Limerick Generating Station, Units 1 and 2

Technical Specifications Change Request No. 93-01-0 Response to Request for Additional information

Supporting Piping and Instrumentation Drawings

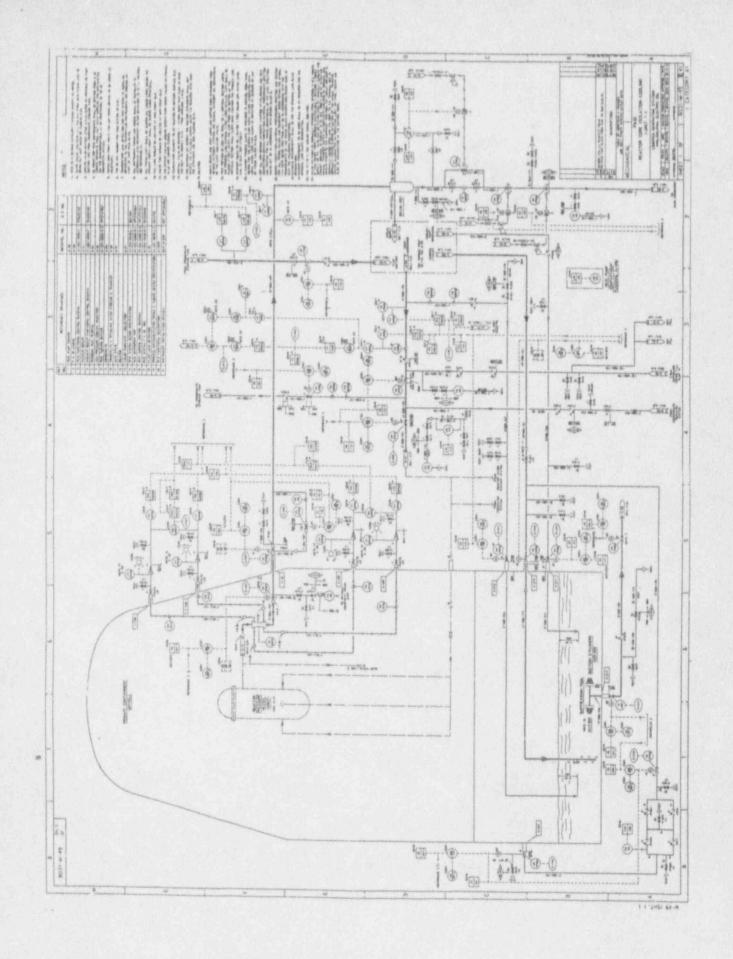
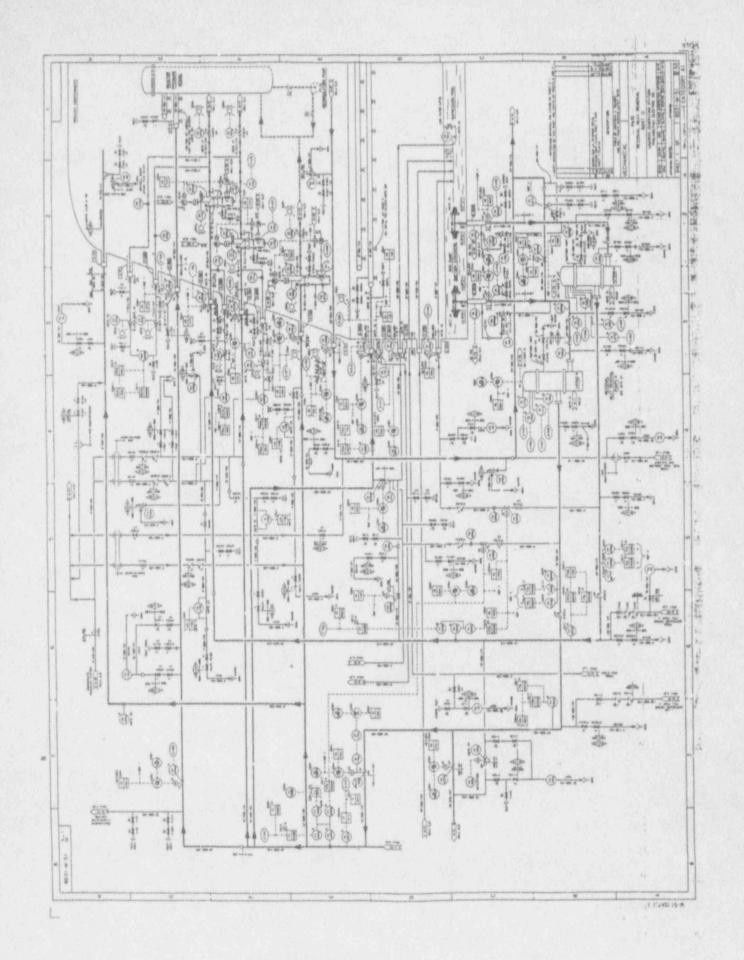
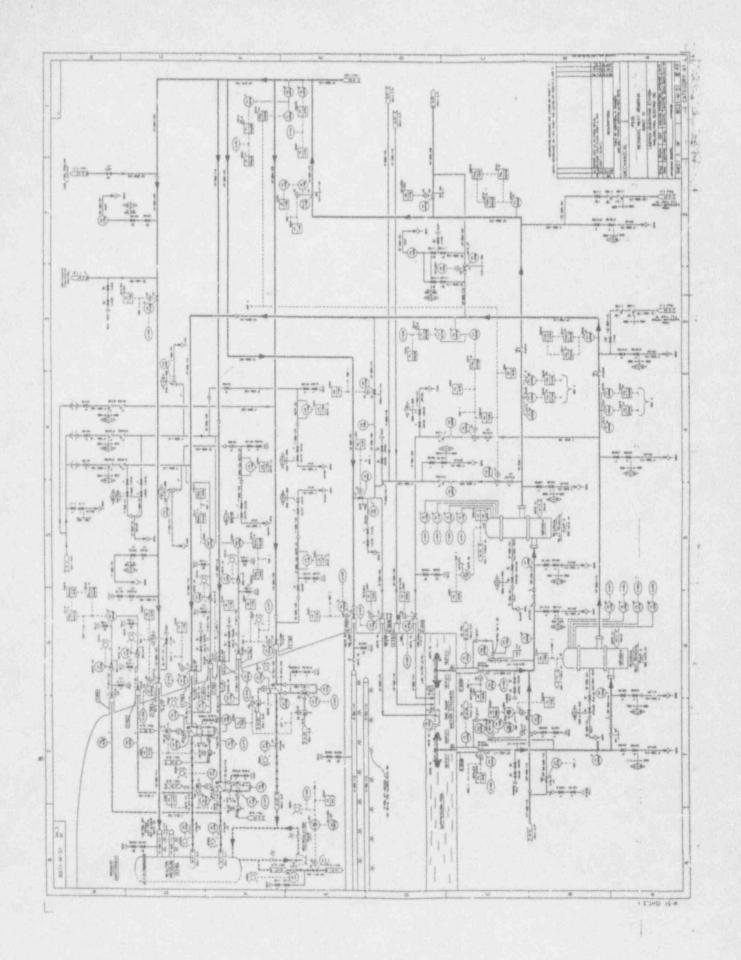
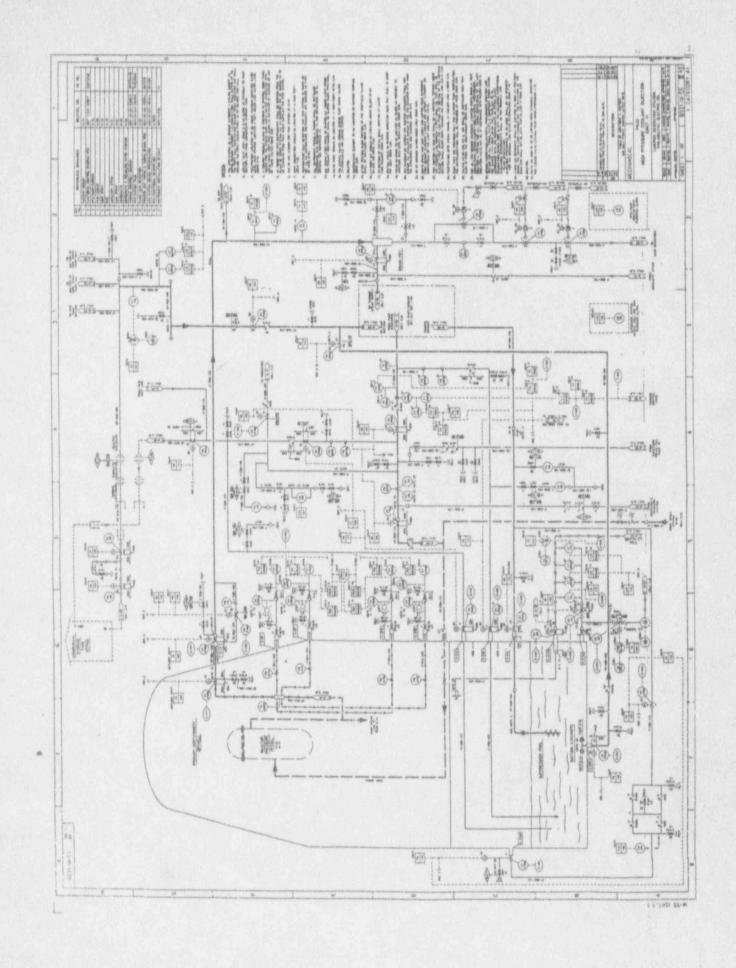
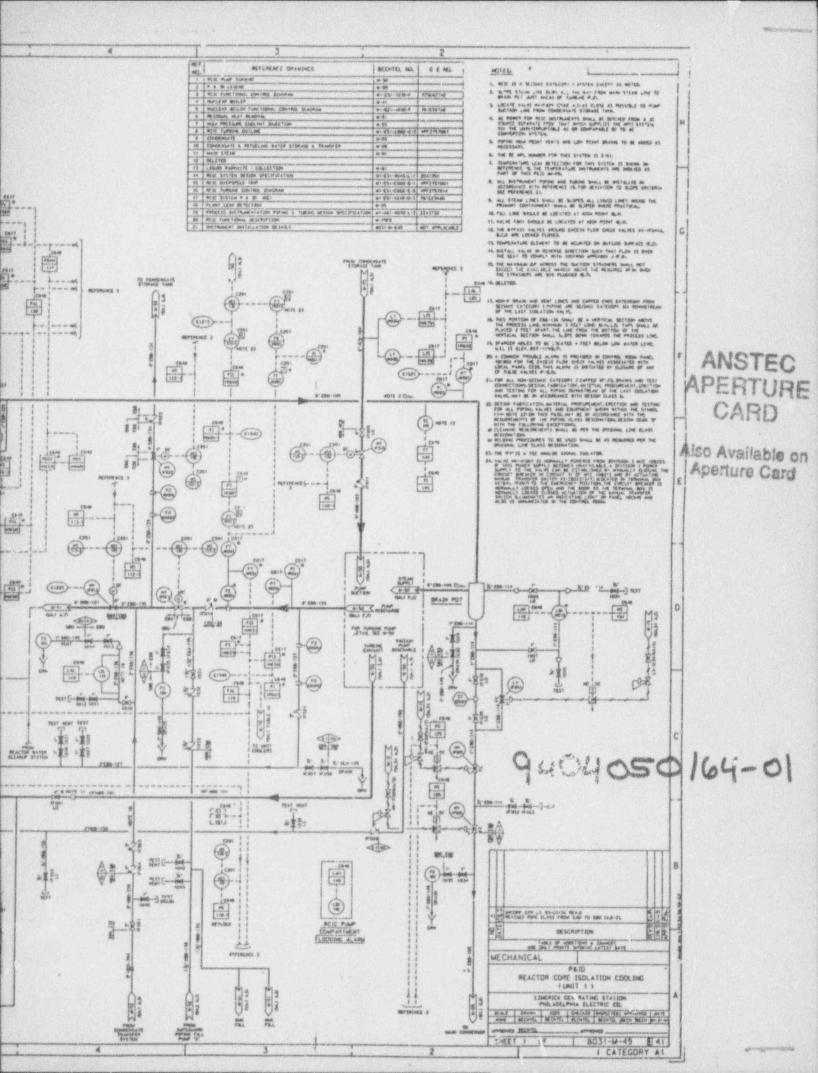
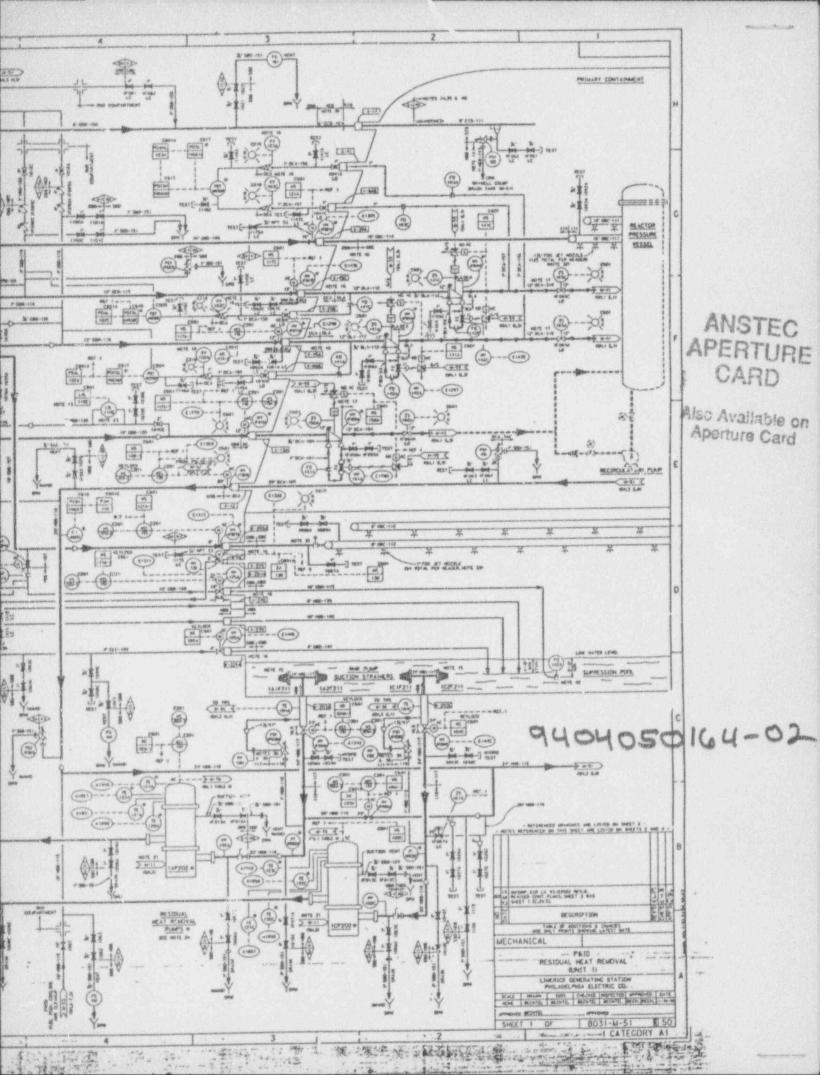
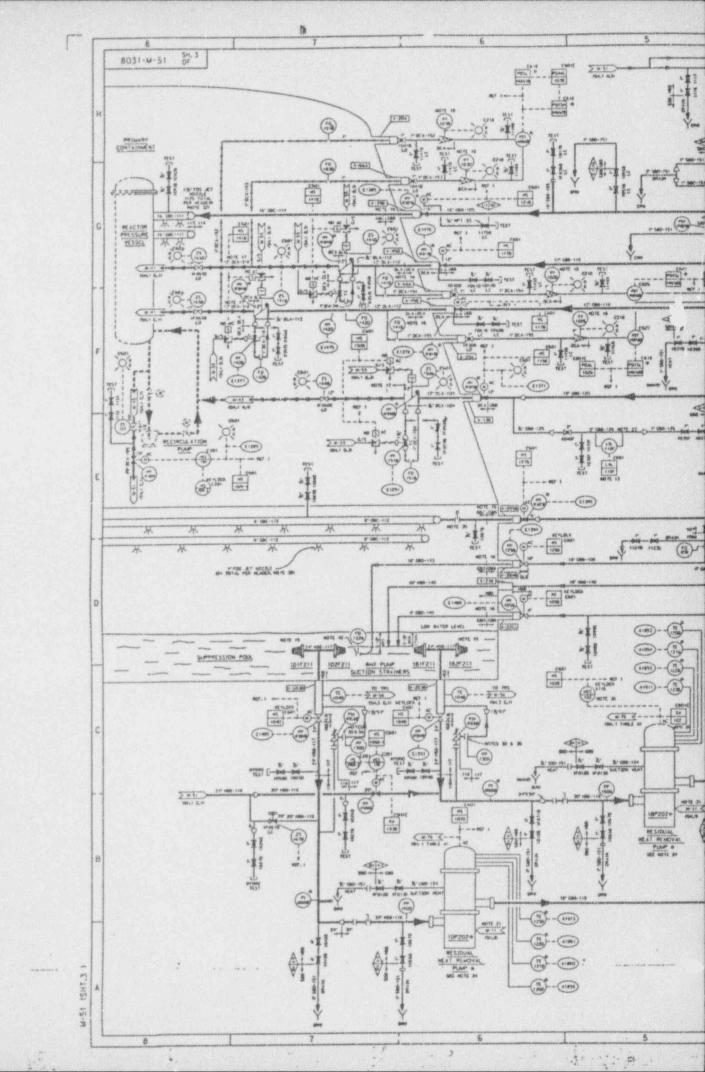
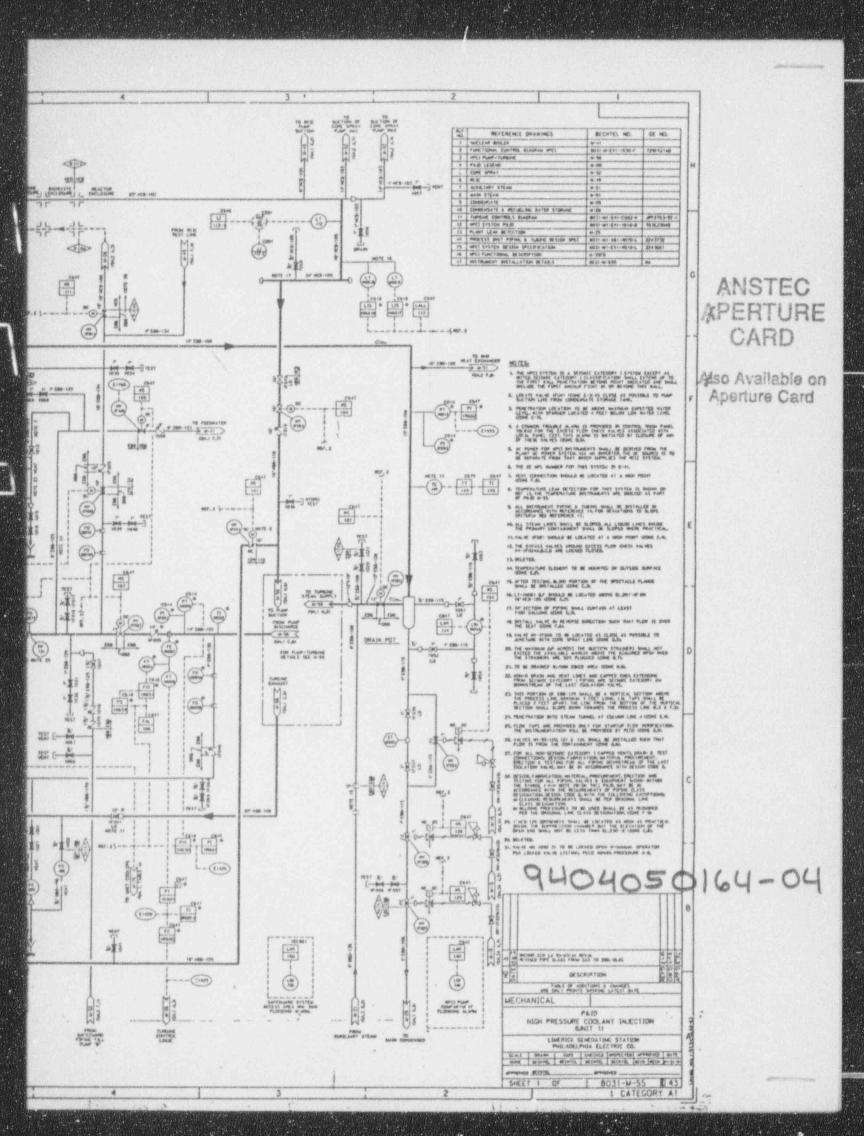
Describe the high point vent layout (e.g., number of vents, locations, elevation schematics and piping and instrumentation drawings, etc.) and describe the vent alarm system. Describe the method used to provide guidance to shift engineers if excessive gas is discovered during venting or if the alarms annunciate.

Describe the safeguard piping fill system used at Limerick. In particular address aspects such as: the elevations of the ECCS and fill piping and where the fill system connects; how the fill system ensures that the system remains full; and the potential for a portion of the piping to fill with gas and/or air and still have the fill system operate with instrument logic showing the system is full.

The high point vent piping layout is illustrated on the attached piping and instrumentation (P&iDs) and isometric drawings. Each loop of the ECCS contains one (1) high point vent alarm. The vents are located at the high point elevation on the associated ECCS pump discharge piping. Level instrumentation (i.e., differential pressure cell level switches) is provided to monitor vent piping level. The TS currently require that a calibration functional ST be performed on this level instrumentation once every 18 months to ensure that the instrumentation is working properly, and is within calibration. The results of the previous STs indicate that the instrumentation is very reliable. The instrumentation is calibrated so that a small drop (i.e., 12 inches of water) in vent piping level would be detected and result in an alarm annunciation in the Main Control Room (MCR) for the affected ECCS loop.

When the Safeguard Piping Fill system pumps are started, suction is taken from the Suppression Pool via two (2) Core Spray (CS) suction lines. The pumps operate continuously, with minimum flow recirculation back to the Suppression Pool through two (2) separate CS suction lines. The system layout is illustrated on the attached system P&IDs. The Safeguards Piping Fill system connects to the CS Loop A and B pump discharge piping and the A, B, C, and D Residual Heat Removal (RHR) pump discharge piping in the vicinity of the pump discharge line check valves at approximately the 177' elevation for both units at LGS. The Safeguard Piping Fill system piping for the High Pressure Coolant Injection (HPCI) system is connected to the pump discharge piping in the vicinity of the 209' elevation on both units. All of these lines connect at a point below the elevation of the high point vent lines.
